**Re: Hoffmantown West Church, 6440 Coors Blvd. NW**  
**Approval of Permanent Certificate of Occupancy (C.O.)**  
**Engineer's Stamp dated 08/24/06 (D-17/D93)**  
**Certification dated 05/22/07**

**Re: Hoffmantown West Church  
Grading and Drainage Plan  
Engineer's Stamp dated 8-29-06 (D12-D1)**

Re: Drainage Report for Hoffmantown West Church, ZAP D-12  
Engineer's Stamp Dated March 28, 2005

**Re: Hoffmantown West Church Drainage Report**  
**Engineer Stamp date 12-28-05 (D12/D1)**

**SECTION A**  
**SCALE = 1" = 4'**

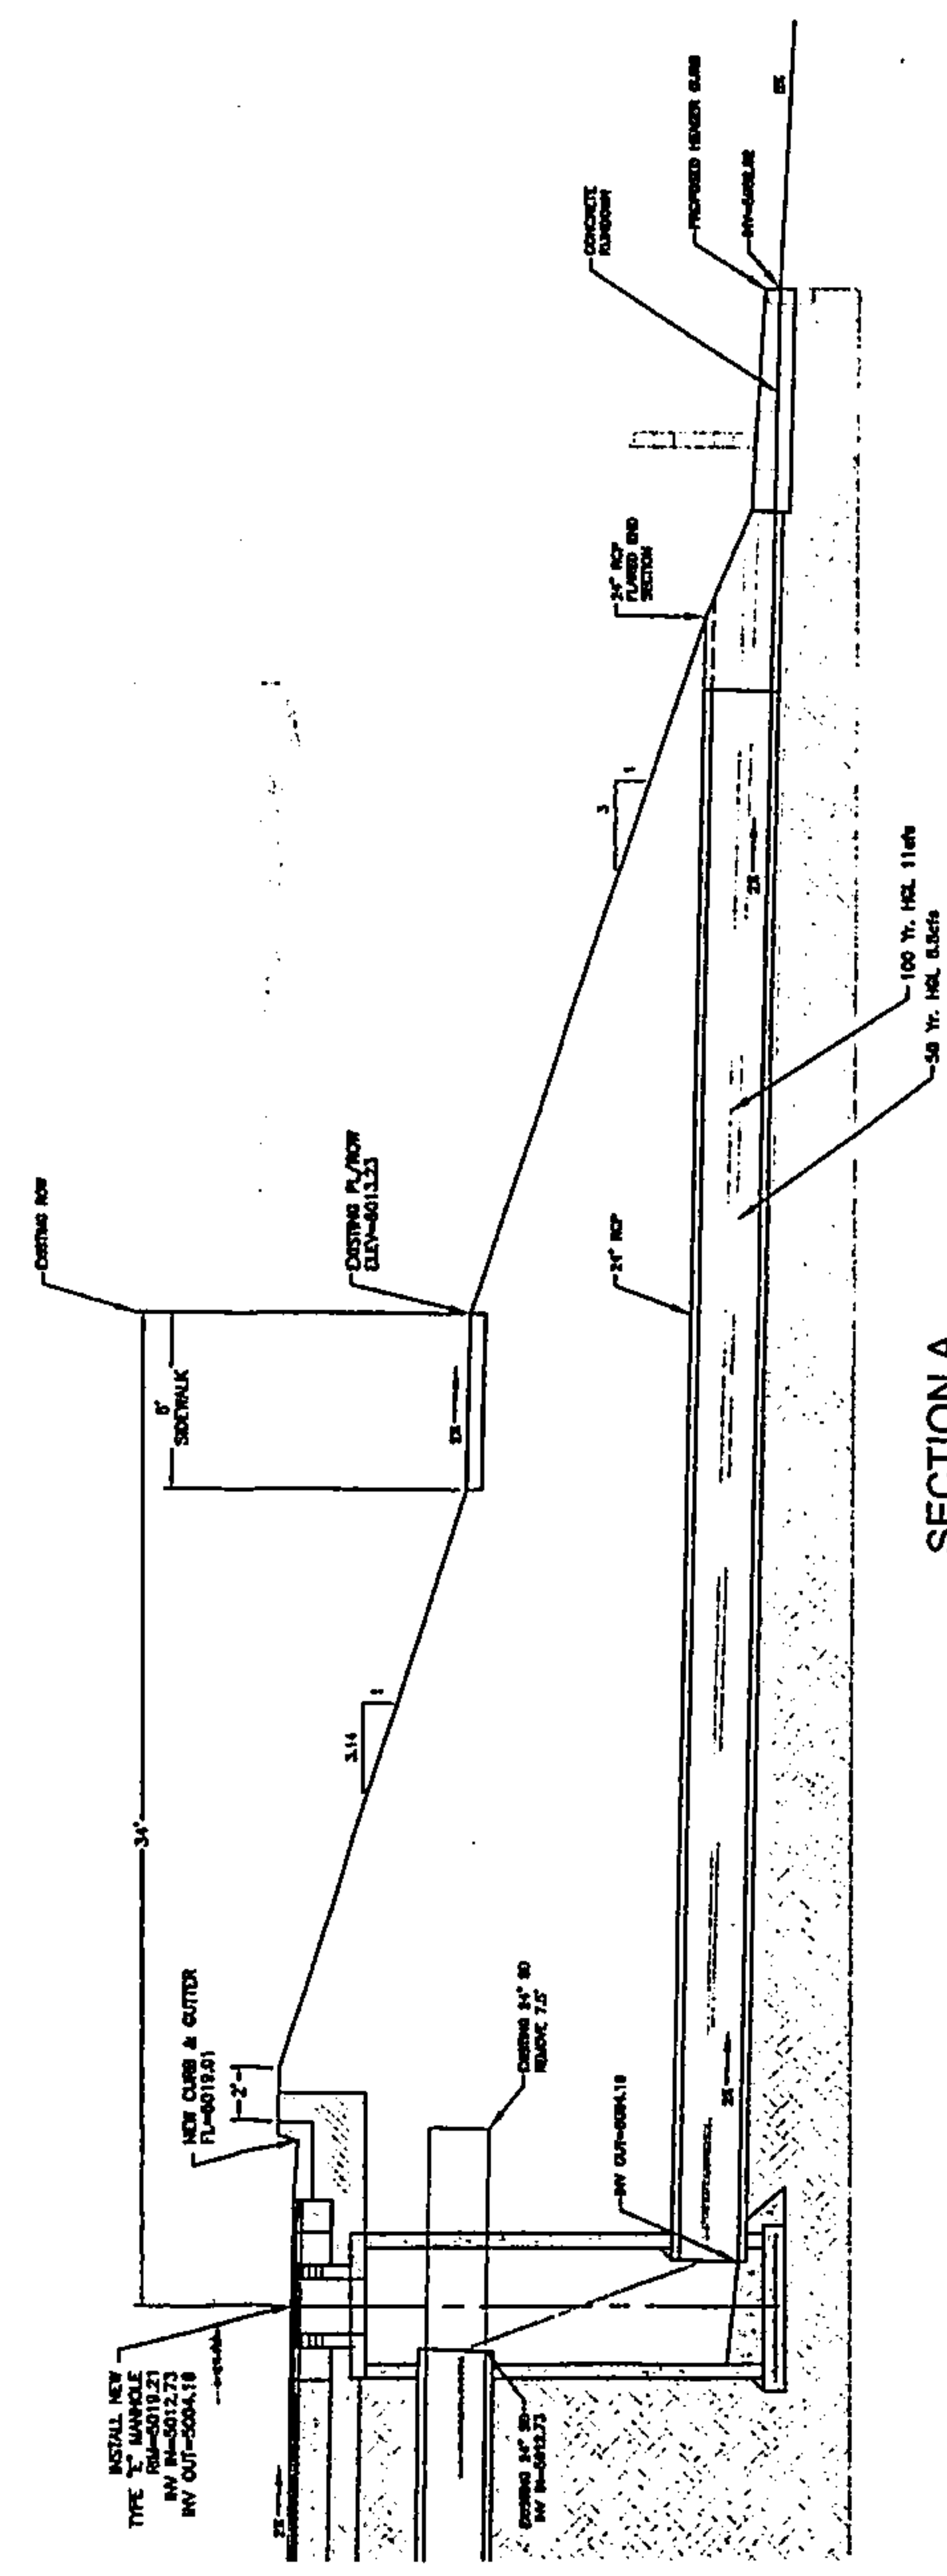
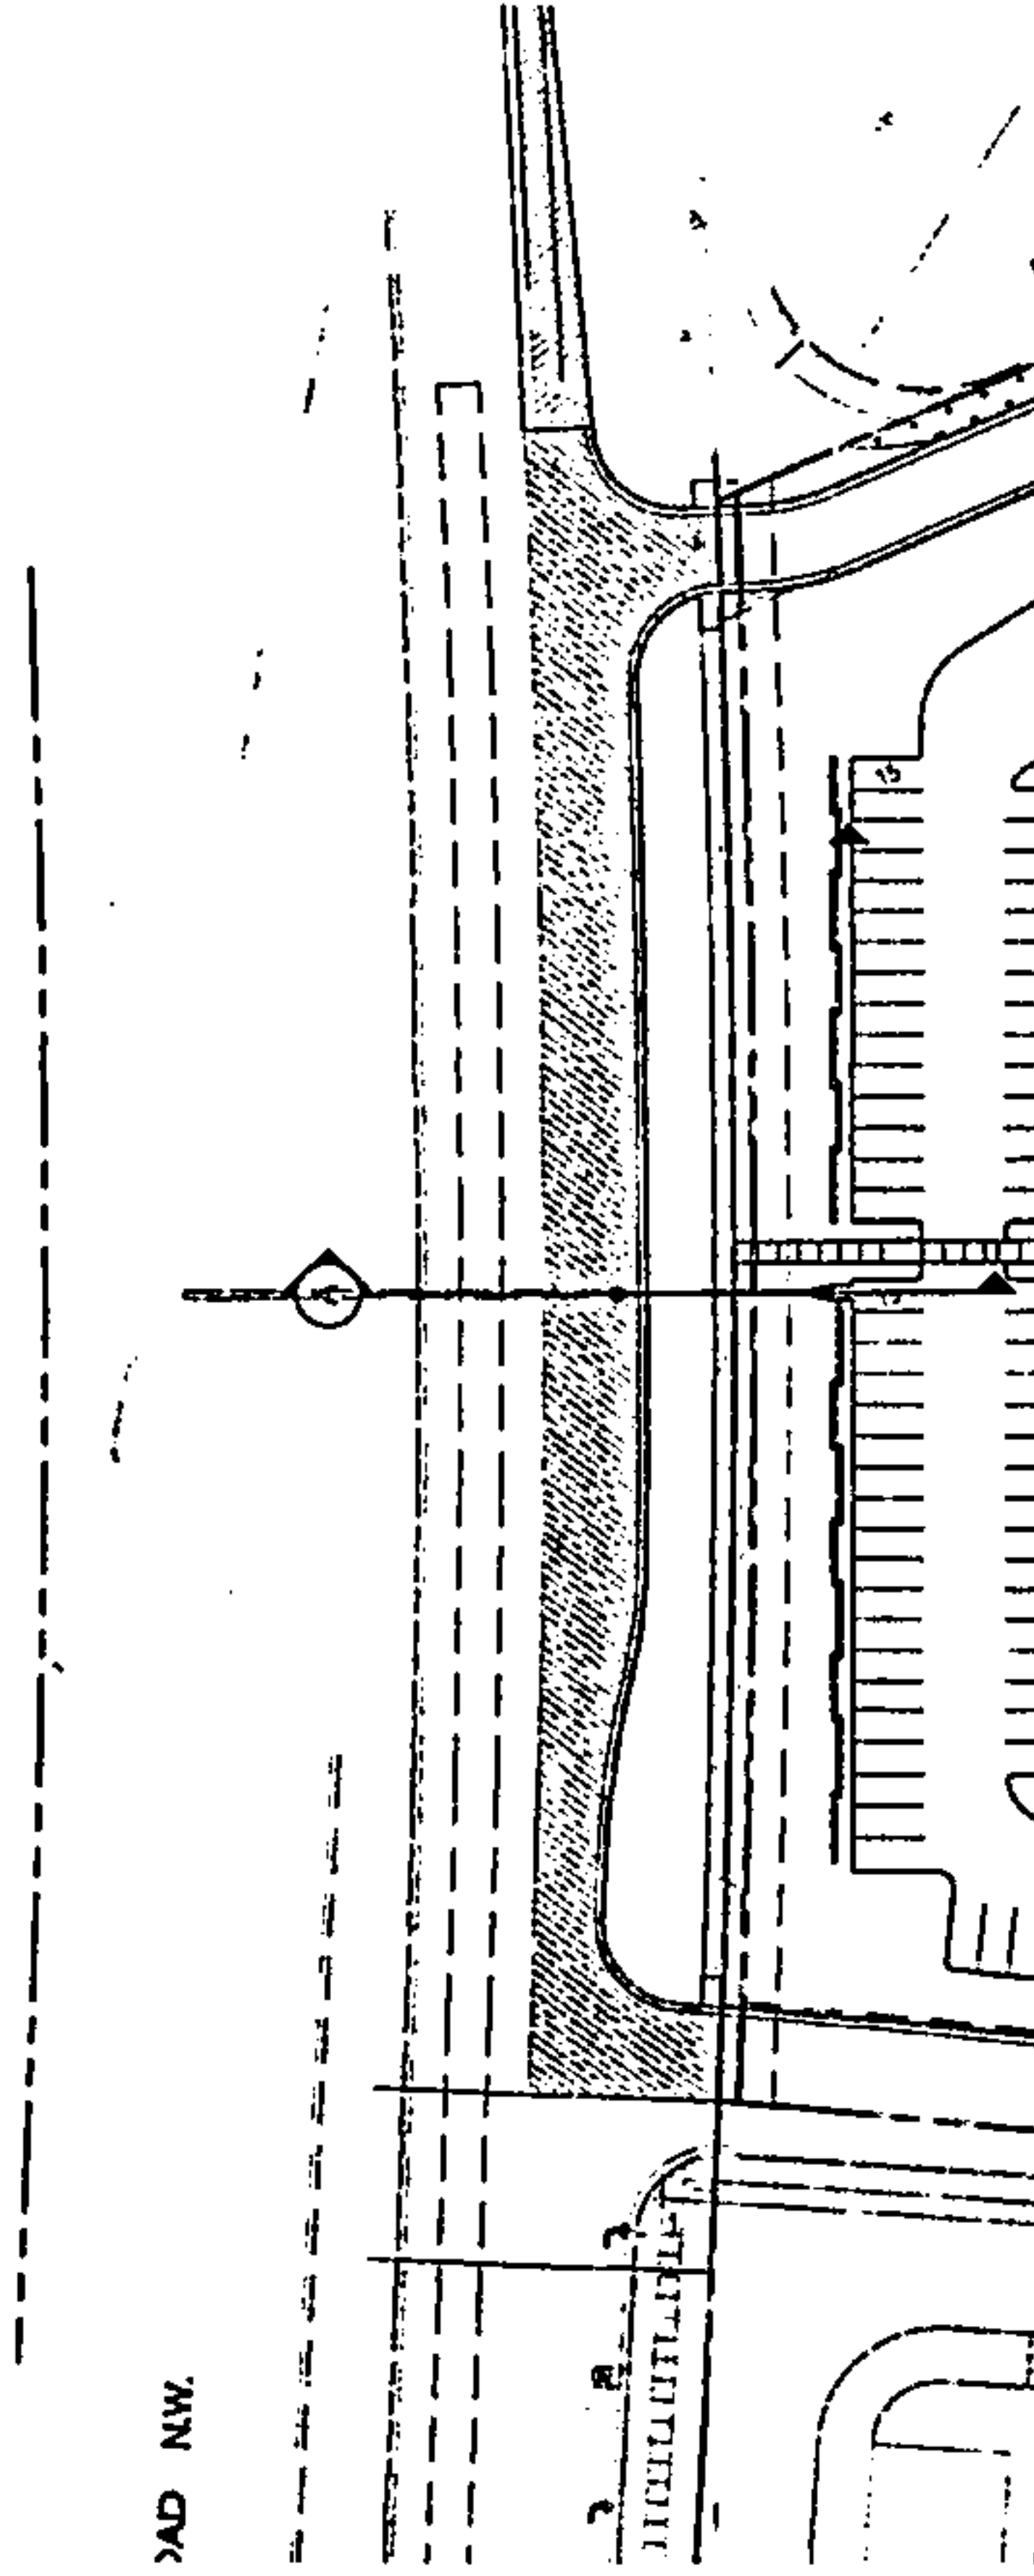
AMAFCA does not approve the Grading & Drainage Plan. There are some key drainage discharge conditions that have not been adequately addressed in the Drainage Report. The primary discrepancy is how you arrived at the allowable discharge rate. This site is included in AMAFCA's "North Coors Drainage Management Plan, Middle Area" (NCDMP, February 1997), which was prepared to update hydrology, development, and discharge conditions in the area. The allowable discharge from Bosque Meadows Subdivision, including the offsite basin that drains through it, is 35 cfs per the NDDMP. Since, according to your report, it discharges 32 cfs, that leaves 4 cfs allowable discharge not going into the canal. The allowable discharge from the Hoffmantown site, including the offsite basin west of Coors Boulevard, is 98 cfs. Please revise the Drainage Report to reference the NCDMP and the allowable discharge.

Another key discharge condition that must be addressed in the report is the desedimentation requirement in the NCDMP. After discussion with MRGCD, AMAFCA and MRGCD are going to require surface water quality treatment for sediment, pollutants and trash and, to be determined on a case by case basis, possibly additional in-line storm water treatment facilities, such as a Stormceptor manhole. There is a pond shown on the southeast corner of the site, but it does not appear to receive any storm water runoff.

The Drainage Report should also address the size and capacity of the existing storm drain outfall to the canal. If you have any questions, please call me at 884-2215.
